**TITLE:** Product Technical Bulletin – PTB112614  
**DATE:** December 8, 2014  
**FROM:** Brian Jacobs, Chemical Process Engineer  
**TO:** All Interested Parties  
**SUBJECT:** Converting puraDYN® PFT & TF Bypass Systems to use Polydry Filters

**2. Removing the Electrical Enclosure (junction box):**

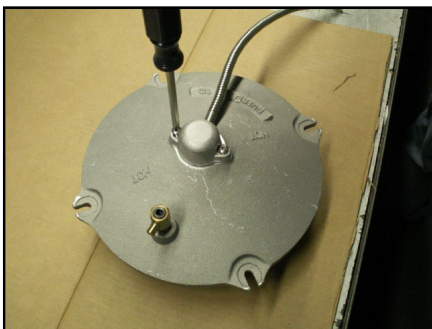
The electrical box (in gray) is located on a post or side mounted next to TF or PFT Units.

The electrical leads from the Puradyn heating element and the pressure switch need to be separated from the box. This can be completed by unscrewing the lead retaining screws and unplugging the leads from the box.

Once all leads are removed and discarded, there should be two bolts that are bolted to the frame rail. Remove the bolts and enclosure from the engine.

### 3. (B) Removing the heating element from PFT Diffuser:

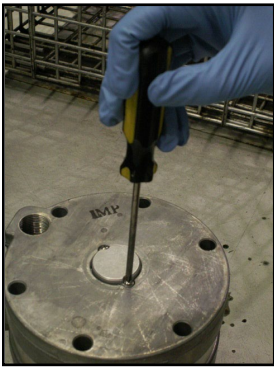
To remove the heating element it is best to remove the puraDYN system from its mounting location to access the bottom of the PFT Unit where the heating element is located.

Using a Philips' screwdriver unscrew the two heater cover screws. Remove heater cover being careful not to lose the 2 washers and screws.

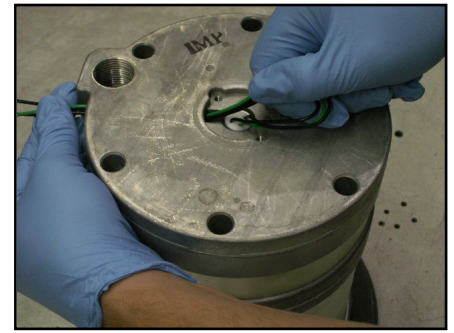
With one hand grab and "push" the wire through the channel. It may require a screwdriver to leverage the wires up before pulling wires by hand. Be careful not to scar the wire insulators.

Next pull the wires out of the channel and remove heating element from the Unit by pulling up on the wires. The heating element should slide out with minimal force.

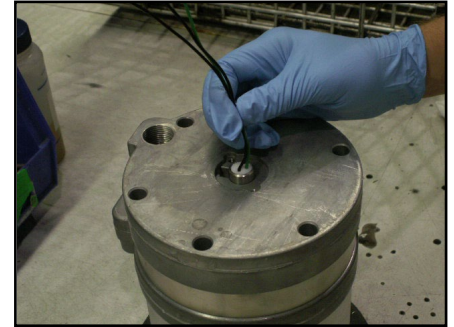
After the heating element has been removed place the heater cover back on the diffuser. Position Lock washers in place and screw heater cap screws down with 12 in-lbs. A small amount of loctite can be applied to prevent the screws from vibrating loose in the future. Mount the Unit back to its original location with correct fittings.

### 4. Replacing the Vent Valve with 1/4" NPT Plug Fitting:

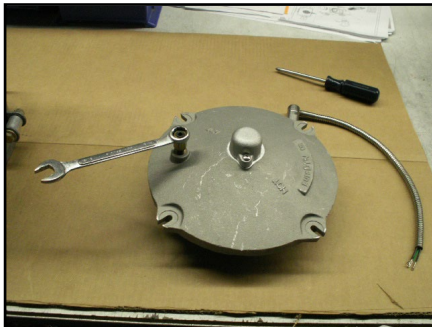
Using a wrench or socket (size 9/16), unscrew the vent valve from the TF Lid (left) or PFT base (right).

Clean up any Teflon tape or sealant residue that may be left behind when the vent valve is removed.

Use 1/4" NPT Plug with Hex Head Fitting (preferably Brass) to plug the vent valve port. Apply Teflon tape or an equivalent sealant (ex. Staybond S592) to the fitting threads. Then tighten the plug fitting into the vent valve port.
